Value Engineering Study
I-64 WESTBOUND TO I-264
WESTBOUND RAMP IMPROVEMENTS
JEFFERSON COUNTY, KENTUCKY

ITEM NUMBER 5-159.00
VE STUDY NUMBER 201203

Final Report

URS conducted a Value Engineering (VE) study of the I-64 westbound to I-264 westbound ramp improvements in Jefferson County, Kentucky. The Item Number is 5-159.00. The topic was the 30% design submission prepared by Parsons Brinckerhoff for the Kentucky Transportation Cabinet (KYTC).

SKETCH OF RECOMMENDED DESIGN

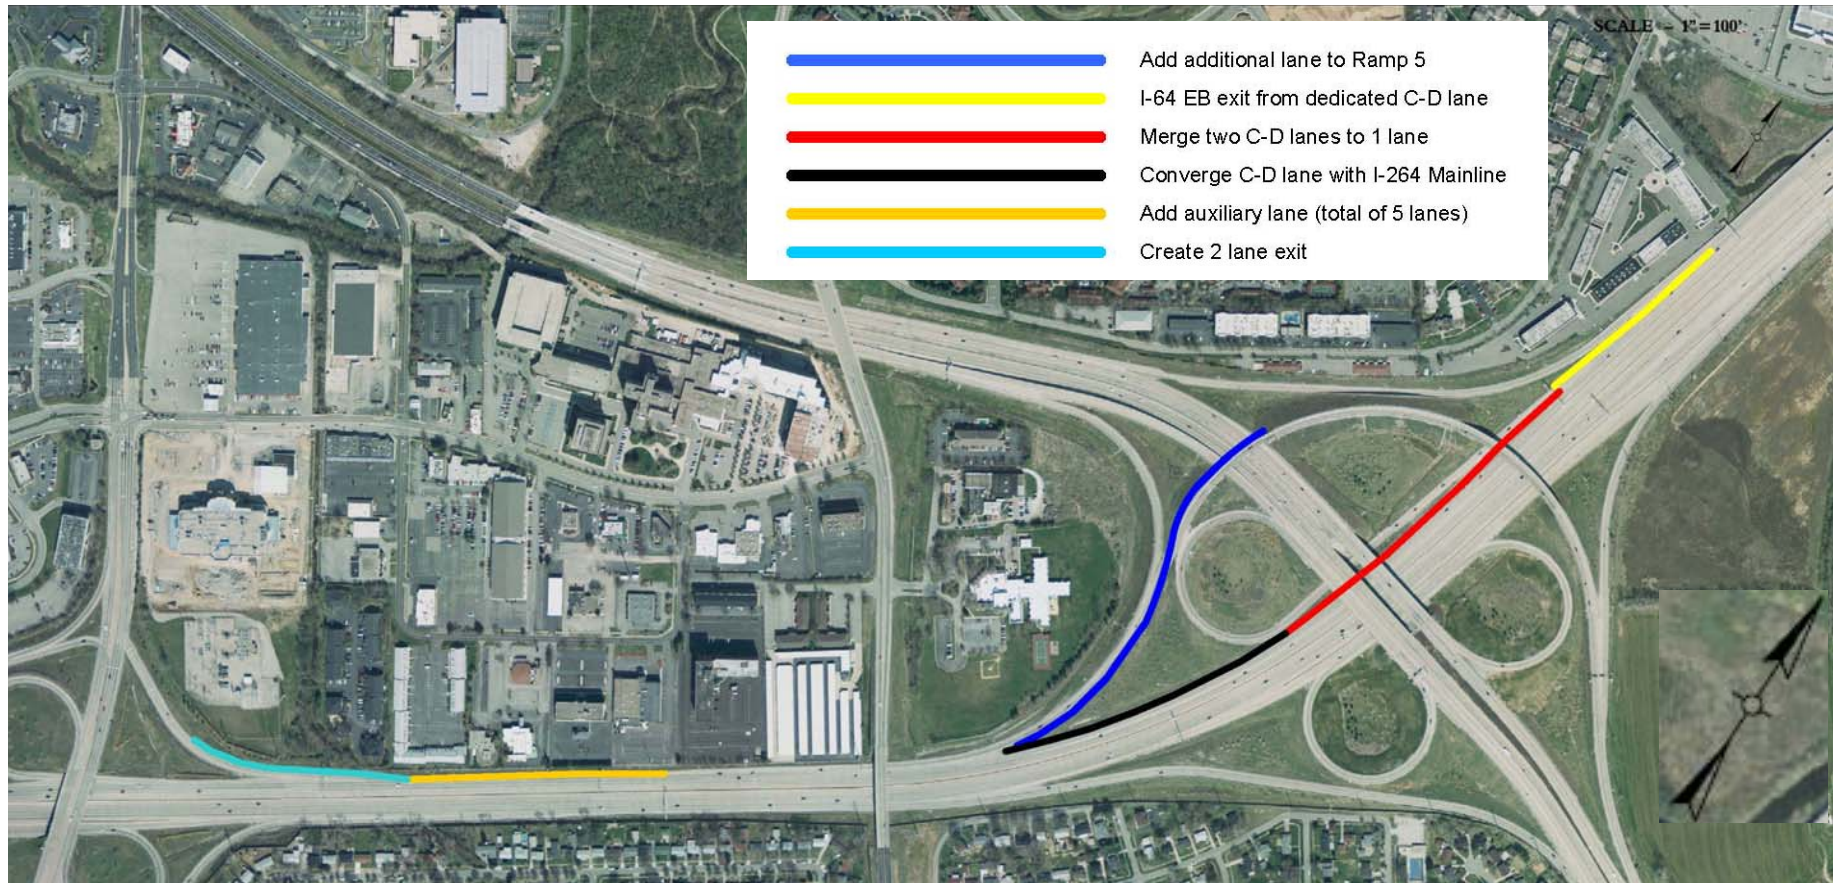
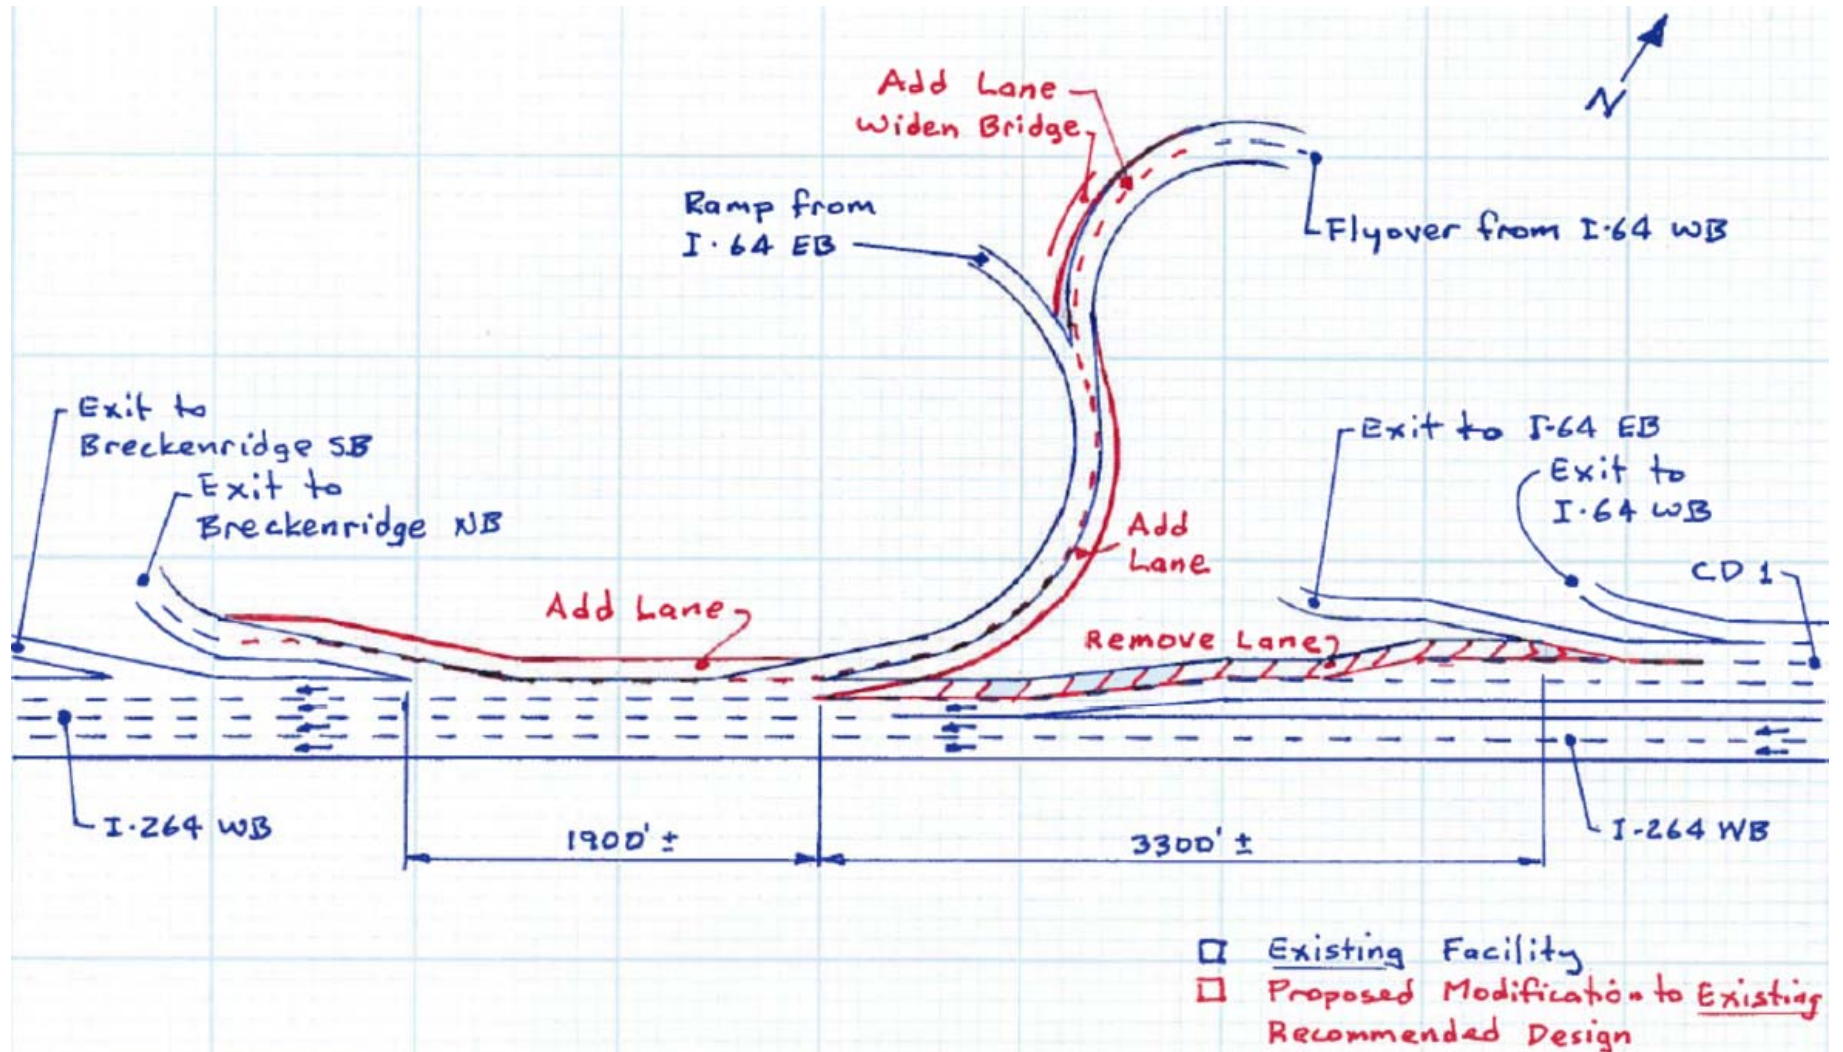
Utilize one lane from C-D Road No. 1 in lieu of two lanes, eliminate the braided ramps, provide a two-lane flyover, and a two-lane exit at Breckenridge Lane northbound in lieu of the original design.

The original design specifies that Ramp 6A, Ramp 9, and C-D Road No. 3 be constructed (from I-64 EB, from I-64 WB, and from C-D Road No. 1, respectively) and braided, to connect with and become Ramp 9. Ramp 9 is to be barrier-separated from I-264 WB mainline and is to be the only WB exit onto Breckenridge Lane NB (“Exit 18B”). Also, modifications are to be made to Ramp 6, Ramp 5, and Ramp 3.
